# Special Meeting of Council Agenda

## 4.1 Amendment C231 - Queens Parade

2. Council prepared Amendment C231 to introduce built form controls for new development along Queens Parade, Fitzroy North/Clifton Hill.
3. Council requested that the Minister for Planning introduce built form controls on a temporary basis through the introduction of two Design and Development Overlays - DDO16 and DDO20 to the Yarra Planning Scheme. The interim DDOs will expire in December 2020.
4. Amendment C231 is intended to replace these interim controls with permanent controls.
5. The table below sets out a timeline of the Amendment.

**Map 3: Location of 390A Queens Parade**

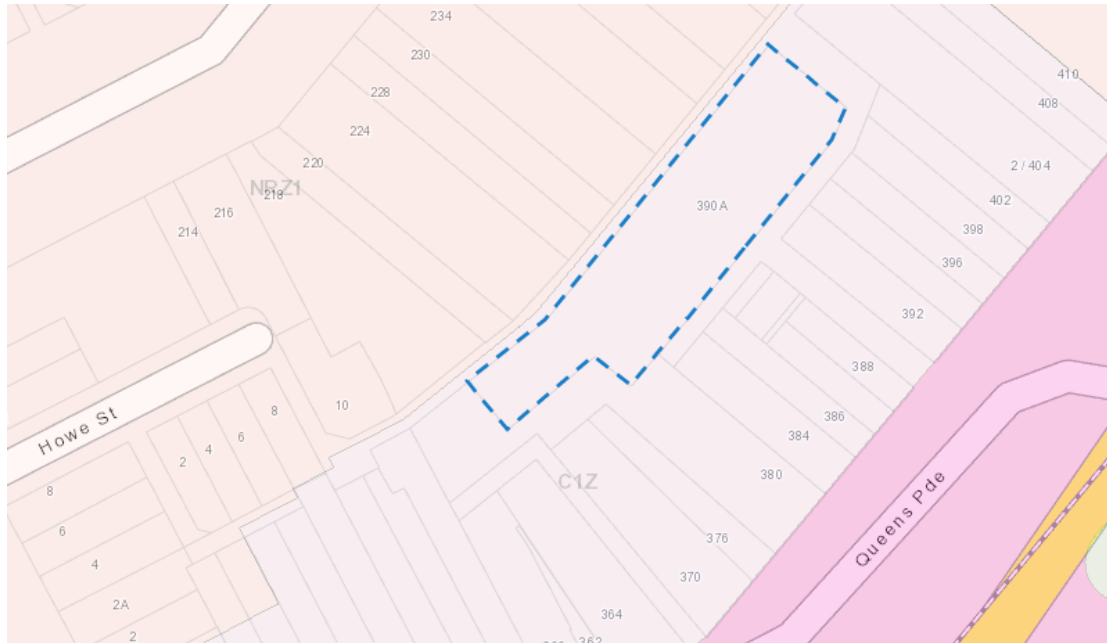
110. 390A Queens Parade is an “island” site located between the rear of the shops on the north side of Queens Parade and the rear of the houses in McKean Street.

117. During exhibition of the Amendment, submissions were received that questioned the *not contributory* grading of the remaining buildings. They considered the rest of the bakery building was significant and should be protected. They argued while some original openings have been closed, the original form and fenestration pattern remain. They said that the single storey building to the immediate south-east of the substation formed part of Wilmott's bakery and should be retained.

- (a) it supported the 'contributory grading of the north-east corner building at 390A Queens Parade and 'not contributory' to other buildings on the subject land within HO330 as exhibited is appropriate and consistent with PPN01' (*Planning Practice Note 1 – Applying Heritage Overlays*);

127. Accordingly, further work is required but the matter cannot be progressed as part of this Amendment. It cannot be progressed because it was never part of this Amendment, it was not exhibited and the owner has not been given a reasonable opportunity to test the propositions in the context of a panel hearing noting that the recommendation came out of the C231 Panel. Therefore, officers are of the view that the issue would need to be pursued as part of a future planning scheme amendment. This would enable the proposal to be fully and properly considered through a public process.
